Working Party on the Transport of Dangerous Goods

Tanks

Marking of tanks carrying flammable liquefied gases that are fitted with safety valves

Transmitted by Liquid Gas Europe on behalf of the BLEVE working group

“6.8.3.2.9.6 Safety valve mark

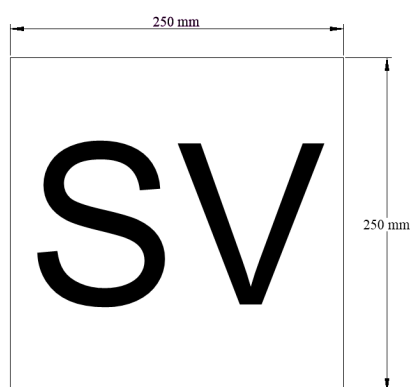
6.8.3.2.9.6.1 Tanks fitted with safety valves in accordance with 6.8.3.2.9 shall display the mark as set out in 6.8.3.2.9.6.2 to 6.8.3.2.9.6.5.

6.8.3.2.9.6.2 The mark shall consist of a white square with dimensions of 250 mm x 250 mm with the letters ‘SV’ 120 mm high in black.

6.8.3.2.9.6.3 The material used shall be weather-resistant and ensure durable marking. The mark shall not become detached from its mount in the event of 15 minutes' engulfment in fire. It shall remain affixed irrespective of the orientation of the tank.

6.8.3.2.9.6.4 The letter 'P' (letters 'SV') shall be indelible and shall remain legible after 15 minutes' engulfment in fire.
